## London Airspace Management Programme 2, Deployment 1.1

### **Annex A**

### **Engagement Evidence**

**Title:** NERL WEST/Severn Group airports engagement meeting

## Revised design (with New COPs and traffic reorientation)

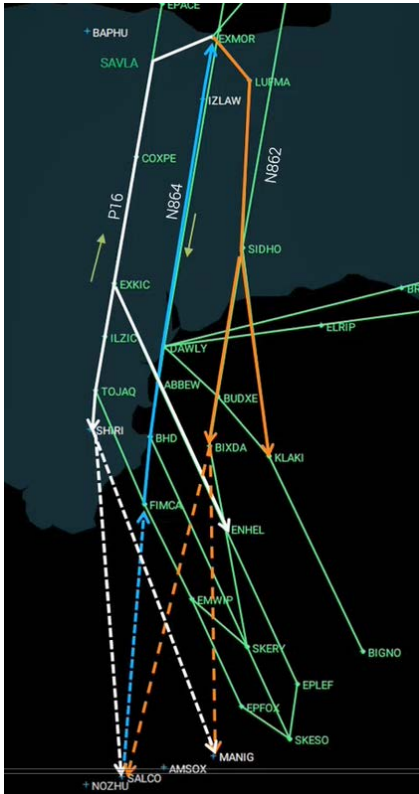
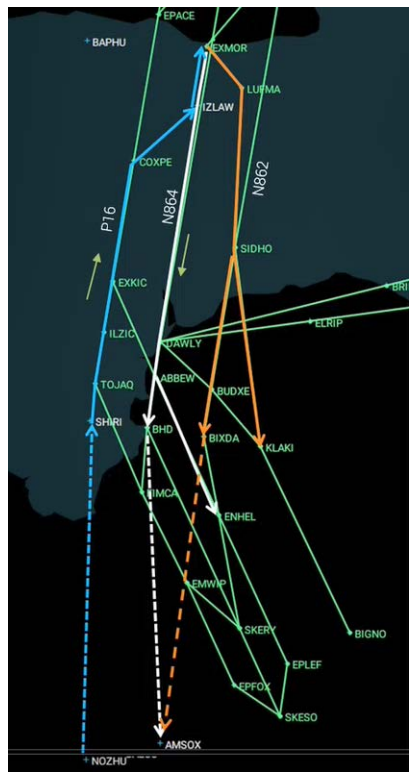
The consulted proposal for the southern interface with Brest ACC included the introduction of two new high-level COPs (one for north bound traffic and one for southbound traffic above FL245). However, Brest ACC changes are required in order to utilise the new COPs and this could not be accommodated in time for the LD1.1 implementation date. The new COPs would therefore exist in a dormant state and current SALCO and MANIG would remain in operation.

ATM Development ATCO stated that during post consultation engagement with Brest ACC, changes to their timeline now facilitate the implementation of these two new COPs in alignment with the deployment LD1.1/FRA D2 in 2023.

These introduction of the two unidirectional COPS (NOZHU – Northbound and AMSOX – Southbound) reduces complexity for both NERL LAC and Brest ACC by allowing an optimised traffic flow around this busy southern interface.

Severn group arrivals were routing northbound on N864, via EXMOR. This was the opposite direction to the FRA trajectories (also highlighted by the green arrows)

Severn group departures were positioned to the west, via EXMOR-SAVLA, southbound on P16. Again, this was the opposite direction to the FRA trajectories.

In this design aircraft would be climbing and descending against, low level, opposite direction traffic.

The revised design introduces full systemisation to the southern interface.

Severn group departures still positioned via EXMOR, but now route southbound on N864.

Severn group arrivals are now reoriented to the west, northbound on P16. To ensure that the aircraft are transferred correctly to the airports, and with no impact below 7000ft, inbounds route COXPE-IZLAW-EXMOR.

## Amendments to STARs.

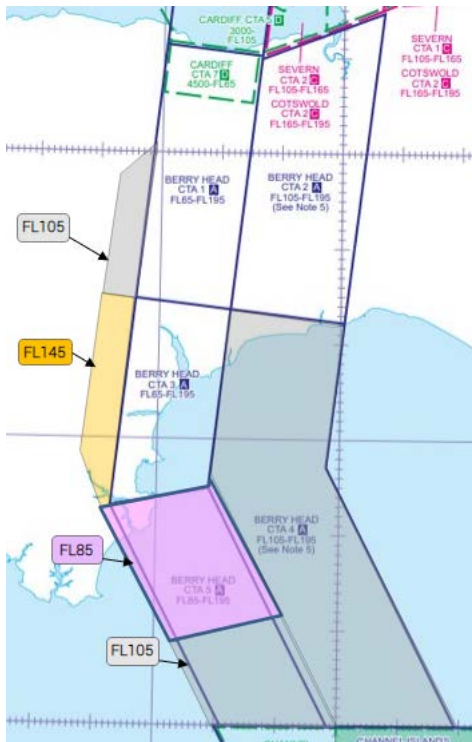
The ATM Development ATCO informed the attendees that achieving full systemisation at the southern interface will require amendments to Bristol and Cardiff STARs.

The DAWLY 1B & 1C STARs will remain as originally proposed, they will be available for RNAV5 traffic only, routing SKESO-BHD-DAWLY.

A new RNAV1 STAR will be introduced from TOJAQ which would track the same profile as P16 to COXPE-IZLAW-EXMOR.

Revised proposal using new COPs

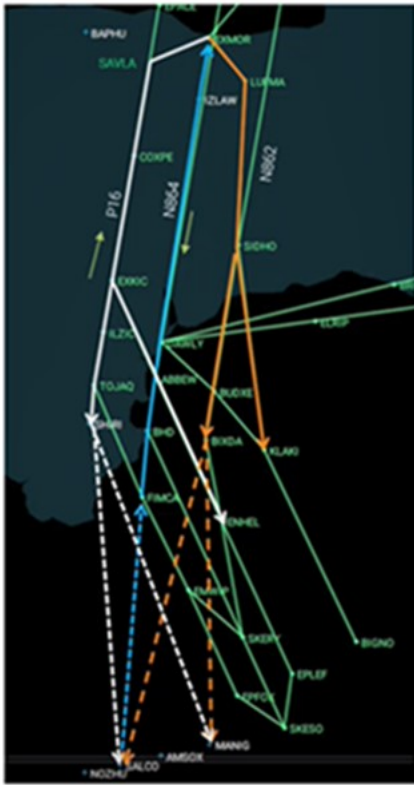
The proposal in our consultation for the southern interface with Brest ACC included the introduction of two new high-level COPs (one for north bound traffic and one for southbound traffic above FL245). The introduction of the two unidirectional COPS reduces complexity for both NERL LAC and Brest ACC by allowing an optimised traffic flow, and full systemisation around this busy southern interface.

However, as Brest ACC system changes are required in order to utilise the new COPs this unfortunately could not be accommodated in time for the LD1.1 implementation date. It was therefore agreed that the new COPs proposed would exist in a dormant state and current SALCO and MANIG would remain in operation until such time that the Brest ACC system changes were ready.

Following this, during our consultation engagement with Brest ACC, they advised that changes to their system deployment timeline will now permit the use of the two new COPs in alignment with the deployment LD1.1/FRA D2 in 2023.

In order to achieve the benefits brought by full systemisation we propose that the new COPS are now fully utilised and plan to update the design following consultation to include this change.

The revision to the traffic orientation for airport arrival and departures allows the NERL LD1.1 ACP to revise (reduce) the volume of CAS required, as shown below:

Revised proposal using new COPs

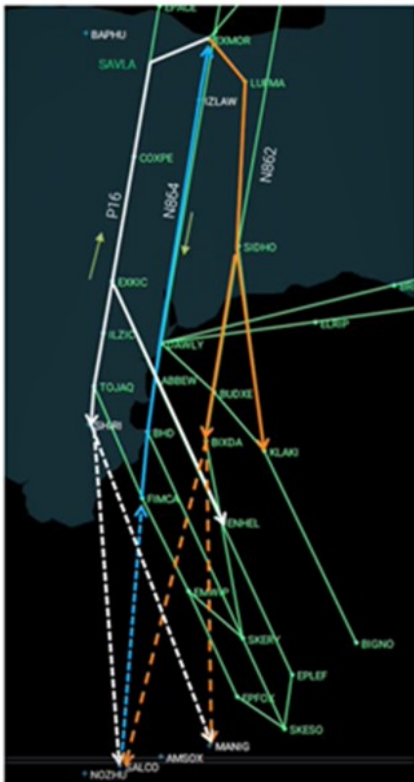
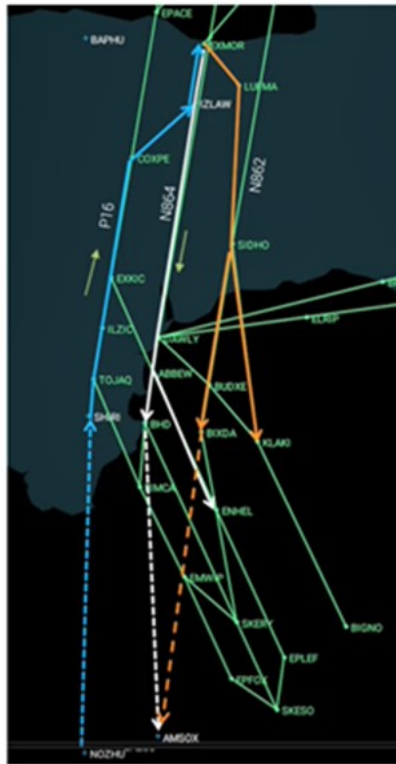
Happy New Year to you too! As you expected, the BGA agrees that the reduction in CAS volume is beneficial.

The proposal in our consultation for the southern interface with Brest ACC included the introduction of two new high-level COPs (one for north bound traffic and one for southbound traffic above FL245). The introduction of the two unidirectional COPS reduces complexity for both NERL LAC and Brest ACC by allowing an optimised traffic flow, and full systemisation around this busy southern interface.

However, as Brest ACC system changes are required in order to utilise the new COPs this unfortunately could not be accommodated in time for the LD1.1 implementation date. It was therefore agreed that the new COPs proposed would exist in a dormant state and current SALCO and MANIG would remain in operation until such time that the Brest ACC system changes were ready.

Following this, during our consultation engagement with Brest ACC, they advised that changes to their system deployment timeline will now permit the use of the two new COPs in alignment with the deployment LD1.1/FRA D2 in 2023.

In order to achieve the benefits brought by full systemisation we propose that the new COPS are now fully utilised and plan to update the design following consultation to include this change.

The revision to the traffic orientation for airport arrival and departures allows the NERL LD1.1 ACP to revise (reduce) the volume of CAS required, as shown below:

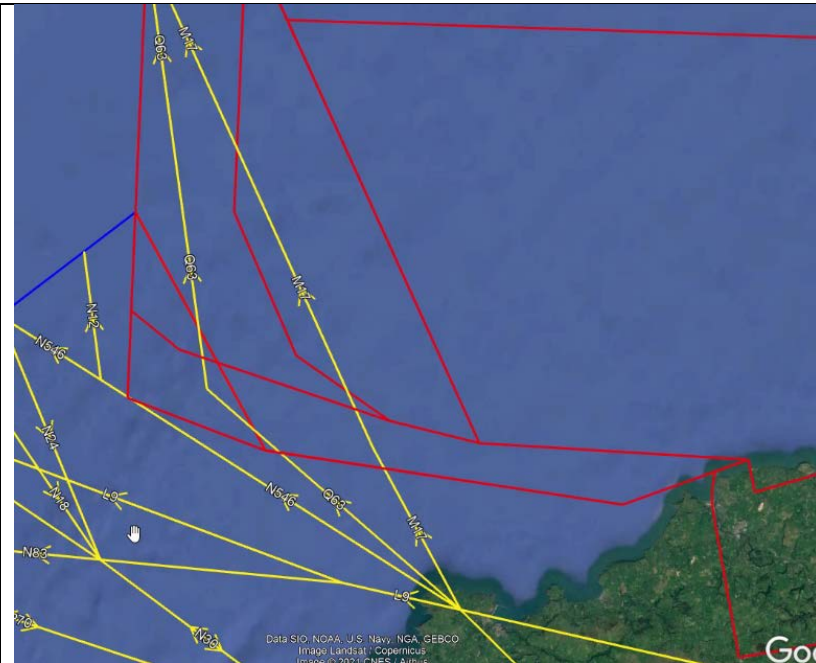
Description	Action
<p><b>Opening</b></p> <ul style="list-style-type: none"> <li>• Welcome and Introductions</li> <li>• Rules of engagement</li> <li>• Meeting recorded for the minutes</li> <li>• Agenda</li> </ul>	
<p>In response to the consultation feedback which was provided by the MoD, the West team have adjusted the proposed dimensions of D201K.</p> <p>The following image was shared with the attendees:</p>

The alterations were explained to the attendees. The picture also displayed what the published route structure will look like, the upper limit of those routes will be FL245 and there will be associated FRA trajectories above them.

QinetiQ ATM Advisor confirmed that the image was as they had expected. West confirmed that the project will proceed with D201K in the displayed configuration.

**Subject:** Cardiff/Bristol STARs Updates

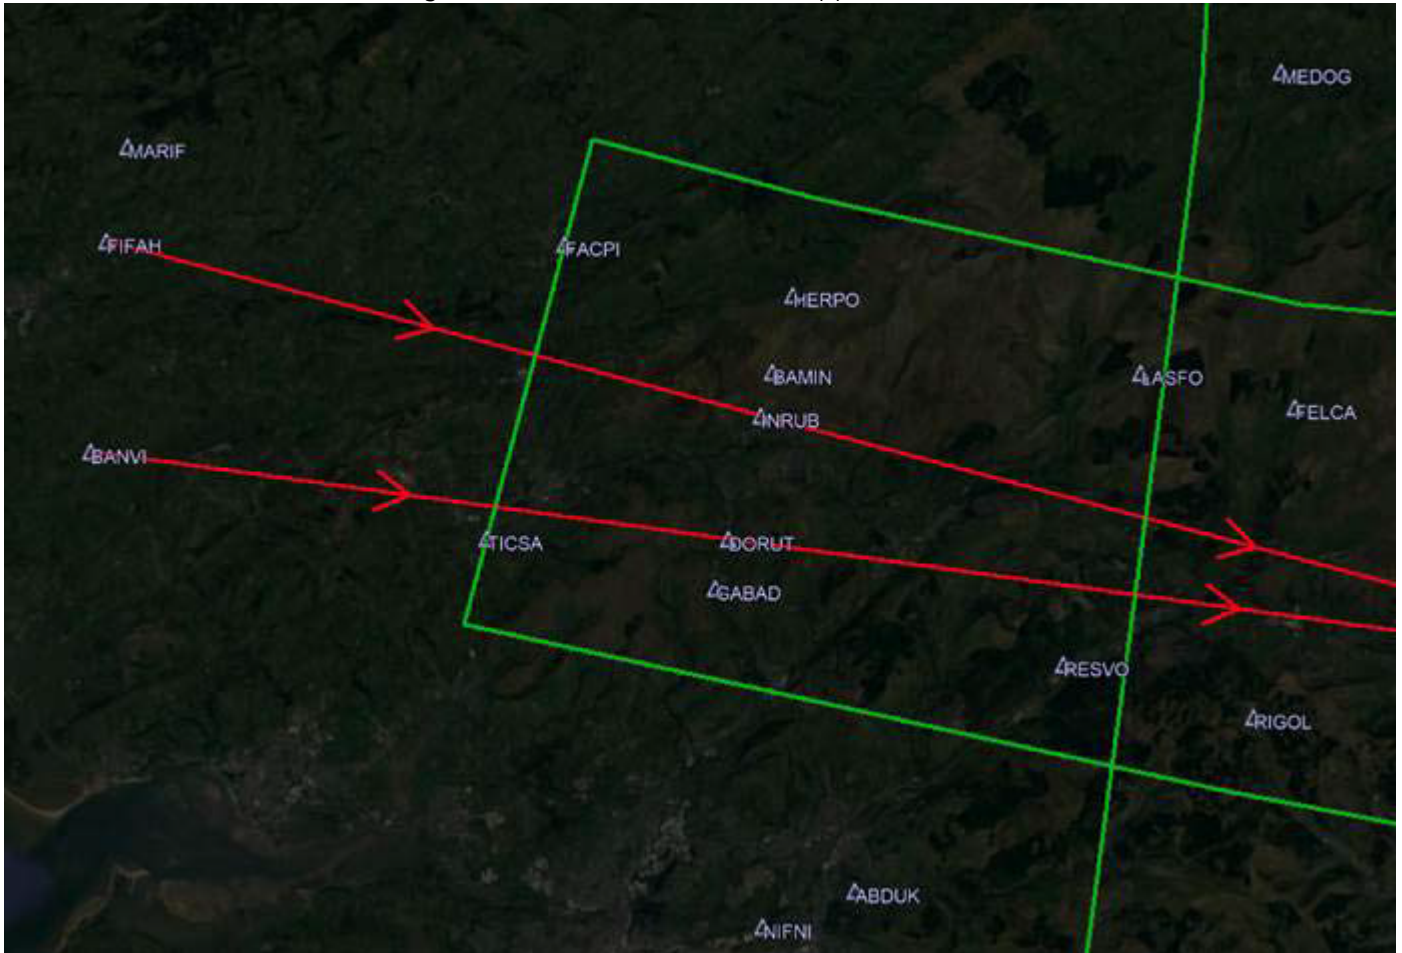
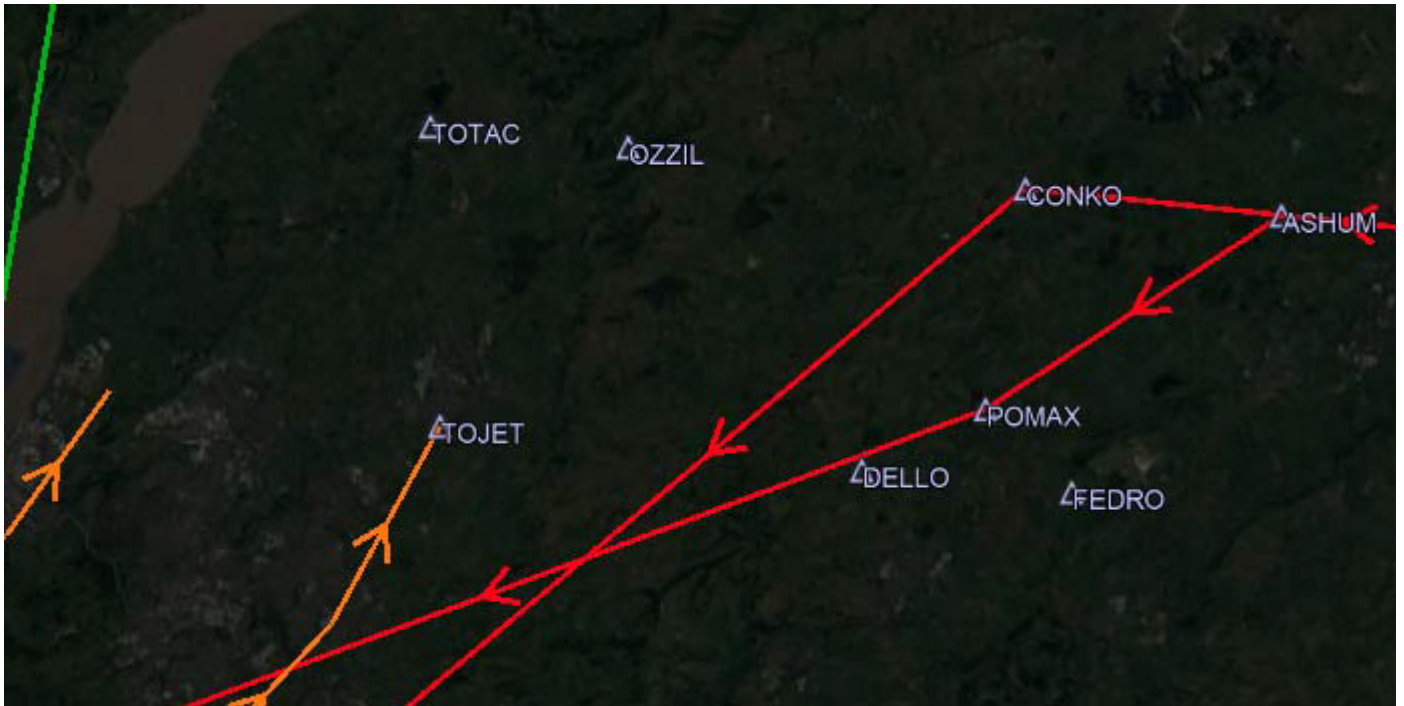
1. The STARs from the west currently have a level restriction of FL170 FIFAH; we would like to propose amending the standing agreement/level restriction on the STAR to FL180 DORUT (working name of new point abeam INRUB) on the RNAV1 STARs for EGFF and EGGD to provide some better fuel efficiency, traffic would be required to descend below FL165 by the S23 boundary, the revised S23 boundary you can see in the image below which is just over 9 NM to the east of DORUT. The FIFAH STAR will remain unchanged as RNAV5 traffic will be capped at FL170 eastbound.

2. In the consultation the inbound routing from the east is described as CPT – Route C to join the STARs on Route C for Bristol/Cardiff. In order to reduce RT complexity we would like to extend the STARs back to abeam CPT to a new point GORZI (working name). Due to our controllers being required to issue full routeings to traffic on first contact this would save an additional three points being stated over the RT and also deconflicts the complexity in the CPT area. The level at GORZI would be FL220 for Bristol and FL260 for Cardiff.

3. We have noticed an instruction has been published at Swanwick recently which alters the NAS designators for Cardiff STARs depending on whether traffic is equipped as RNAV5 or RNAV1, do you require this change to be applied to the new Cardiff STARs? And if so please can you confirm this is Cardiff only and not Bristol too?

- 1) Happy with the new FL180 level- (assuming this will be introduced with the new airspace?)
- 2) Not an issue for Cardiff
- 3) Yes please, it helps us to identify whether aircraft are RNAV 1 capable or not

1. For Cardiff to reply
2. No issue for Bristol.
3. Bristol has one RNAV-1 STAR for each Runway which is via EXMOR (ADVED1A and BAXUN1A). The plate already has a note instructing pilots to request the STAR with Cardiff from 2300 to 0600L and LAC outside these times. The STAR has a different route and termination point; therefore we require notification of a pilot's intention to fly it.
